**CITY OF FORT LAUDERDALE**

## **DEVELOPMENT REVIEW COMMITTEE (DRC) COMMENT REPORT**

**Project Name:** Cedar Lofts Alliance LLC / Las Olas Townhomes

**Case Number:** R15058  
**Request:** Site Plan Level II Review: 7 Townhouse Units

| DATE         | REVISION           |
|--------------|--------------------|
|              | SP-102             |

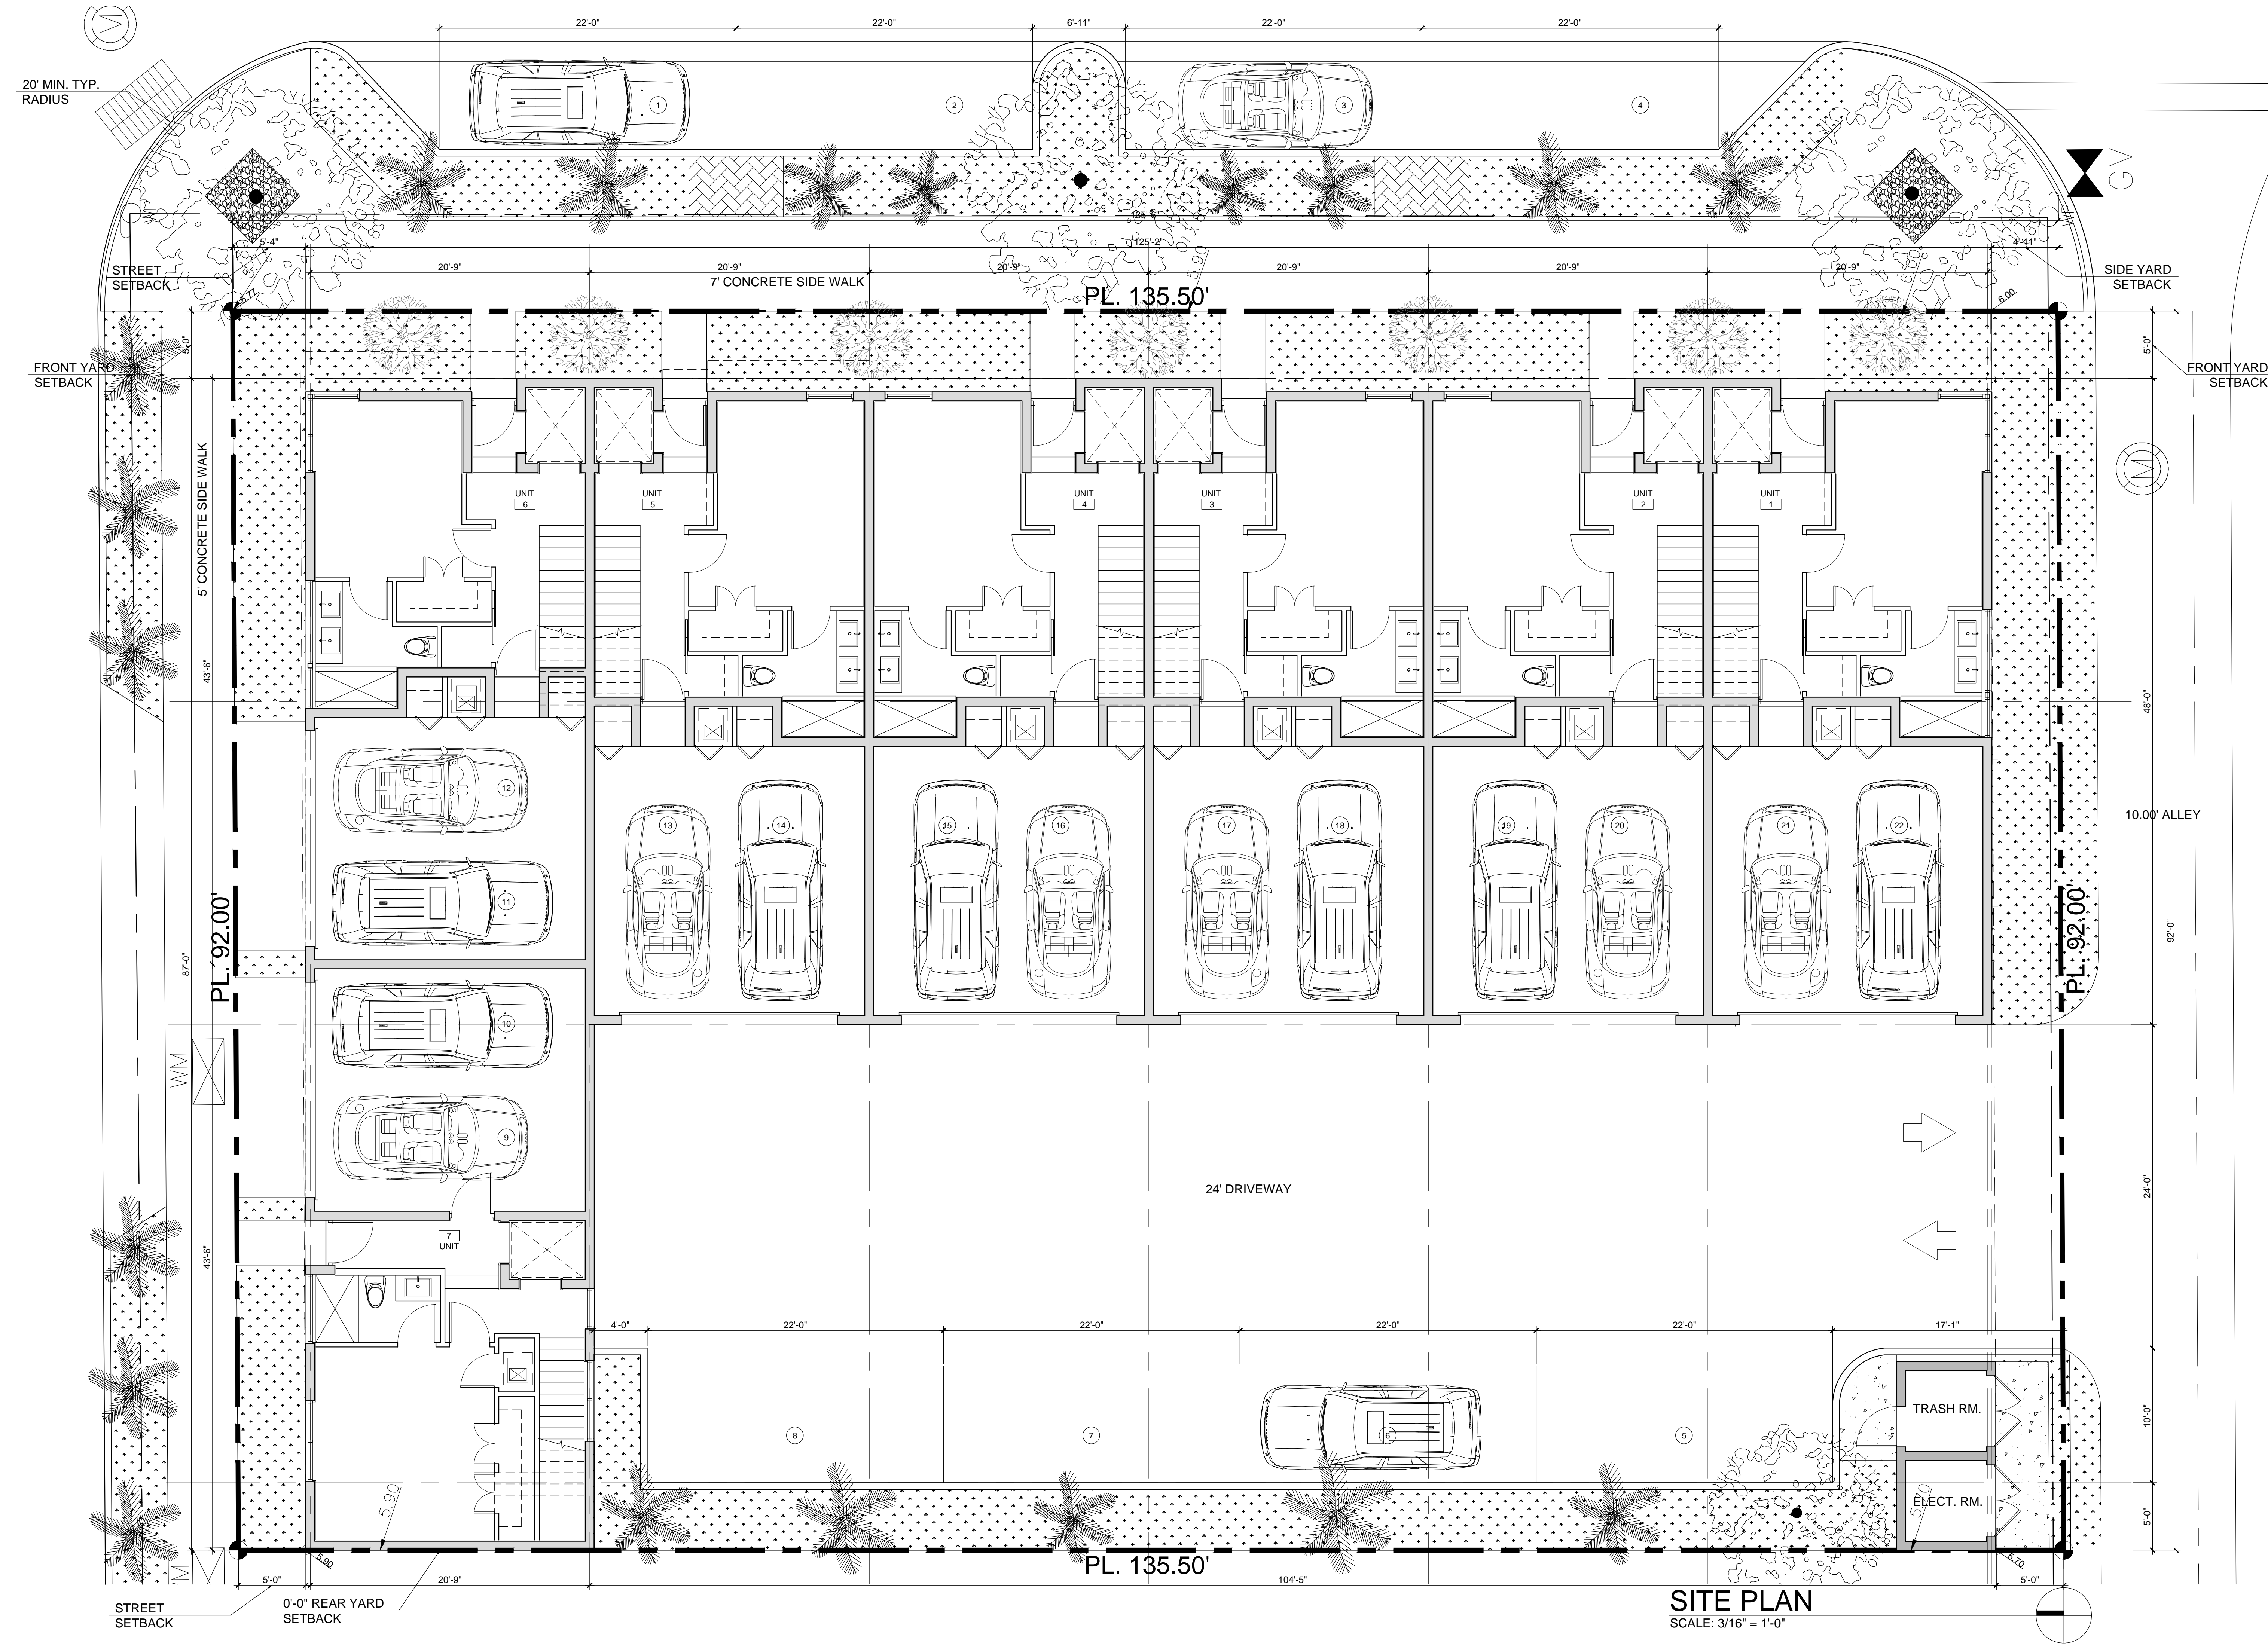
4. Shift proposed sidewalk along N.E. 2<sup>nd</sup> Street to be just beyond the existing Right-of-Way boundary, and within the requested 5' Right-of-Way Easement dedication on the south side of N.E. 2<sup>nd</sup> Street.

5. Per ULDR Section 47-2.2.Q, show and label sight triangles as appropriate for safe and adequate access of drivers and pedestrians, on the Site Plan, Landscape Plans, and Civil Plans: intersections of driveways with streets (measured from pavement edges), alleys with alleys (measured from property lines extended), alleys with streets (measured from property lines extended), and streets with streets (measured from property lines extended). Per ULDR Section 47-19.1.E, no accessory use or structure shall be permitted within a sight triangle except as provided in [ULDR Section 47-35](#).

6. Shift and/or remove proposed on-street parallel parking spaces adjacent to the proposed development along N.E. 2<sup>nd</sup> Street and N.E. 7<sup>th</sup> Avenue, which encroach into the 25' corner sight triangle (intersection of a street and a street) or 15' corner sight triangle (intersection of an alley and a street).

8. Dimension typical roadway travel lane widths and parking lane lengths/widths on the Site Plan for the proposed development side of N.E. 2<sup>nd</sup> Street and N.E. 7<sup>th</sup> Avenue. Instead of proposed concrete curb along N.E. 2<sup>nd</sup> Street and N.E. 7<sup>th</sup> Avenue, show and label concrete curb & gutter (FDOT – Type F), while maintaining 10' (min.) width for adjacent travel lane per the master plan.

9. Per ULDR Section 47-20.5.C.6, provide and dimension the minimum stacking distance required for driveway ingress to and egress from the proposed parking area – a minimum 12' x 22' area for each vehicle to be accommodated for stacking; coordinate with parking area gate access if appropriate.

- 6) Provide all setbacks on the site plan, page SP-2.
- 7) Provide legible photometric plan for the entire site. Extend values on photometric plans to all property lines. Show values pursuant to the Unified and Land Development Regulations ("ULDR"), Section 47-25.3.A.3.a and 47-20.14. Indicate lighting poles on site plan and landscape plan, and provide detail with dimensions.

8. Provide on the site plan a garbage truck turning radii for City review. Drive aisle width and design configuration must allow for safe and efficient maneuverability on-site and off-site. Indicate how truck will circulate to/from/within property.

7. Ensure by showing on the site plan that a full sized vehicle can safely access and exit the 4<sup>th</sup> on-site parallel parking space. Please consider removing the space if necessary turning movements cannot be made.

A-201

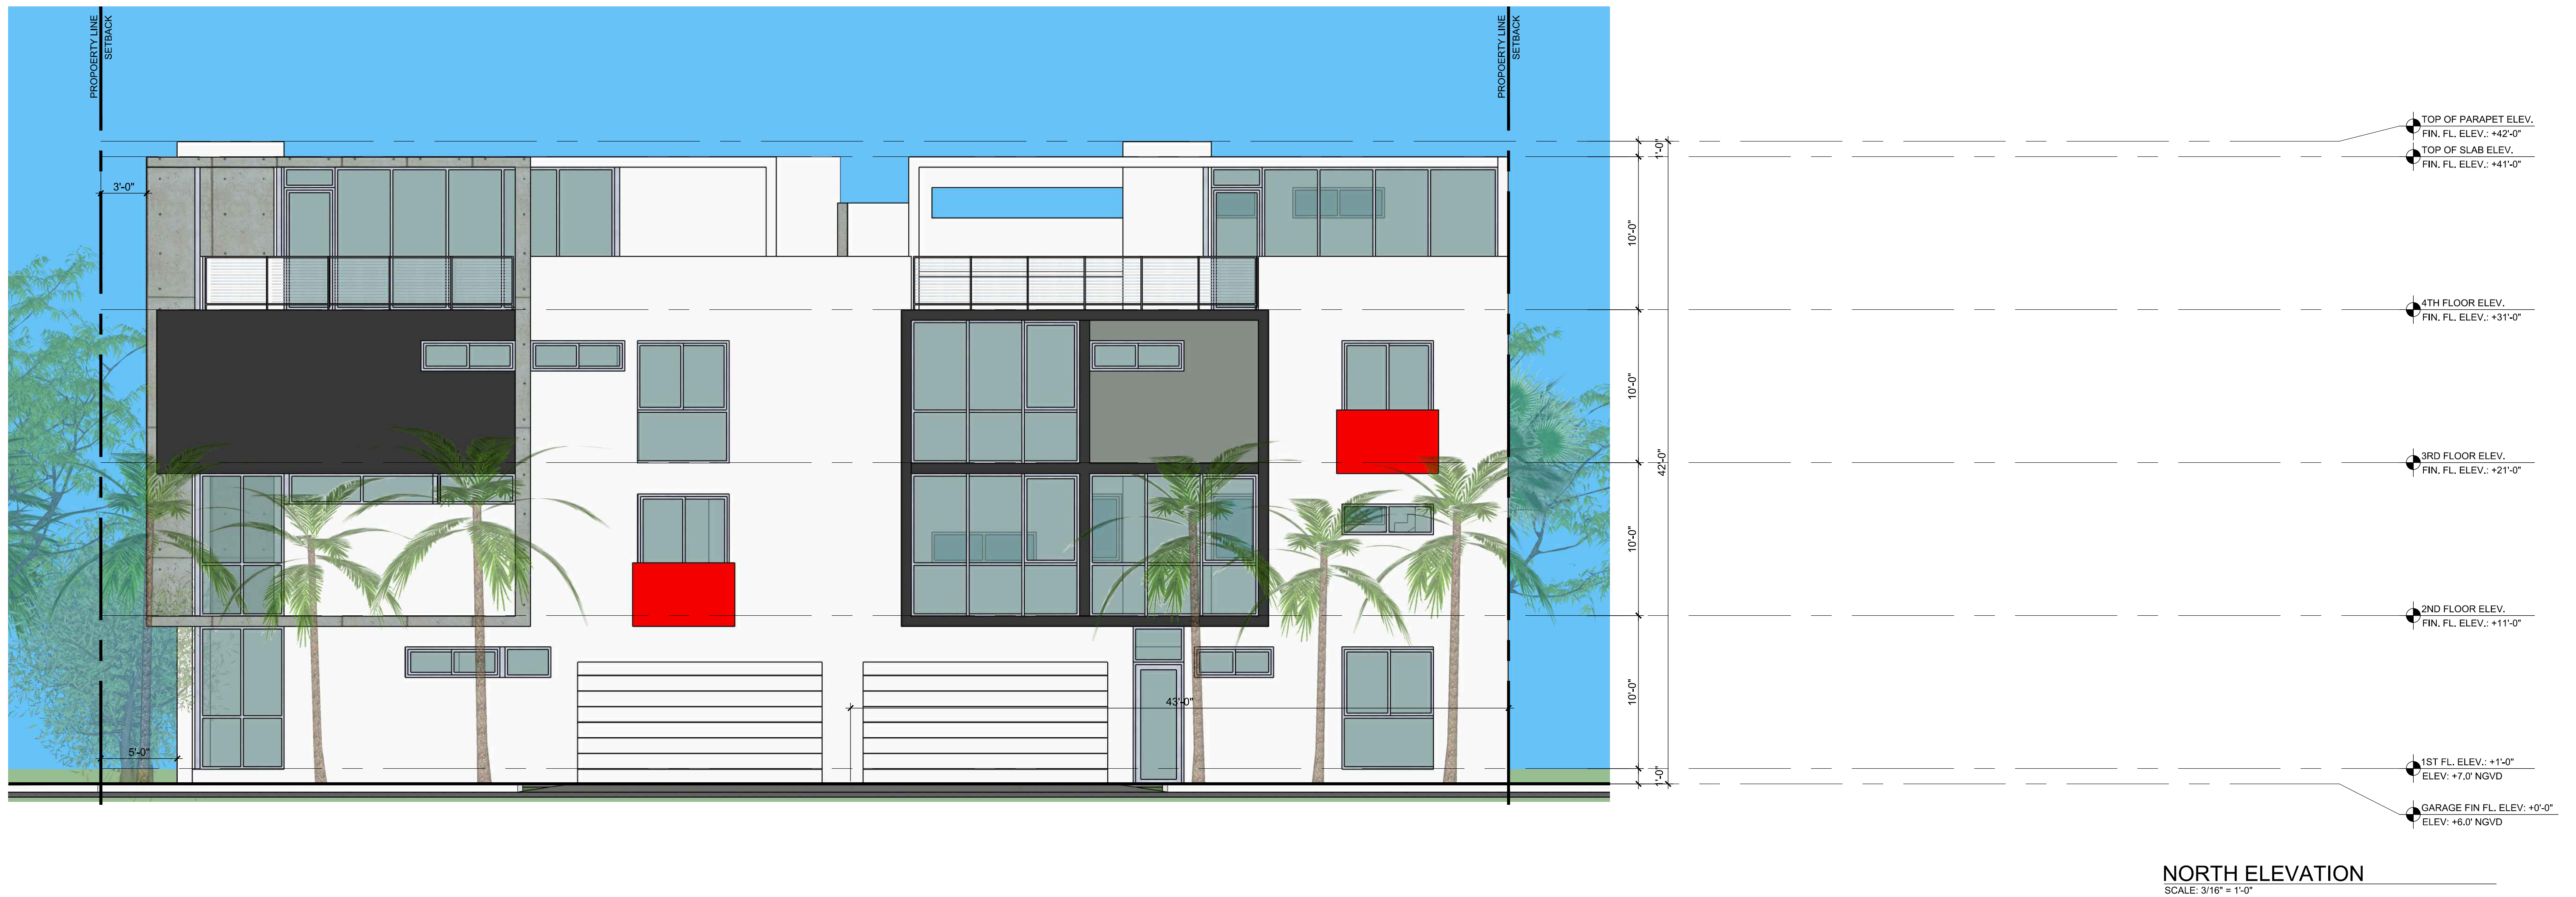
- 8) Correct the application and site plan based on the building height as defined in the ULDR. Maximum building height is measured from the highest habitable point of a structure. If the roof terrace has a partially covered roof, then that would be calculated as the maximum height. Otherwise the maximum height would be calculated as the height of the railing for the roof terrace.
